SUNDRY NOTICES AND REPORTS ON WELLS

☐ Oil Well ☐ Gas Well ☒ Other: INJECTION8. Well Name and No.
MCA UNIT 449

30-025-39429-00-S1

WELLBORE SKETCH
ConocoPhillips Company -- Permian Basin Business Unit

WELLBORE SKETCH
ConocoPhillips Company -- Permian Basin Business Unit

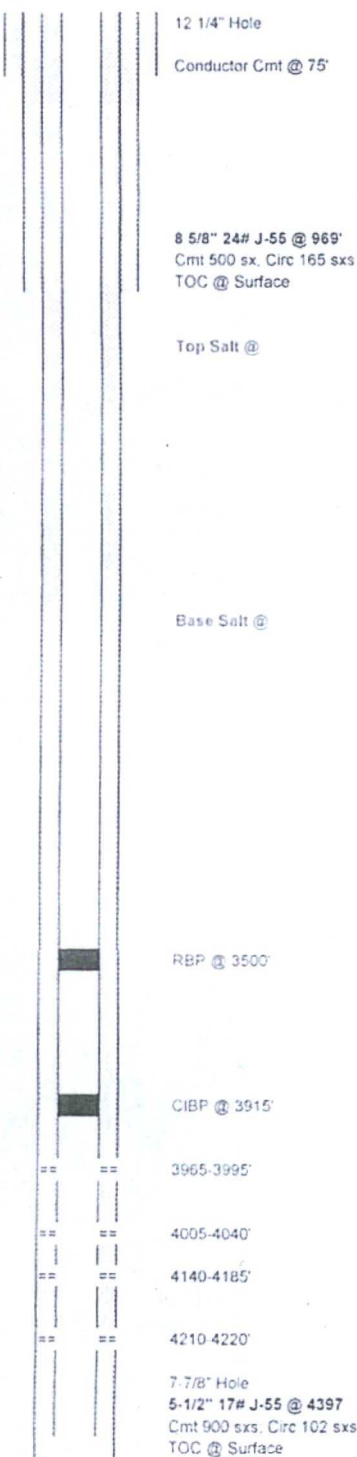
8 5/8" 24# J-55 @ 969'
 Cmt 500 sx, Circ 165 sxs
 TOC @ Surface
 Spot 35sx cmt @ ~~1160~~-1600' Tag
 Top Salt @ **1160**

Spot 55sx cmt @ ~~2336~~-1800' Tag
 Base Salt @ **2336 - 1836**
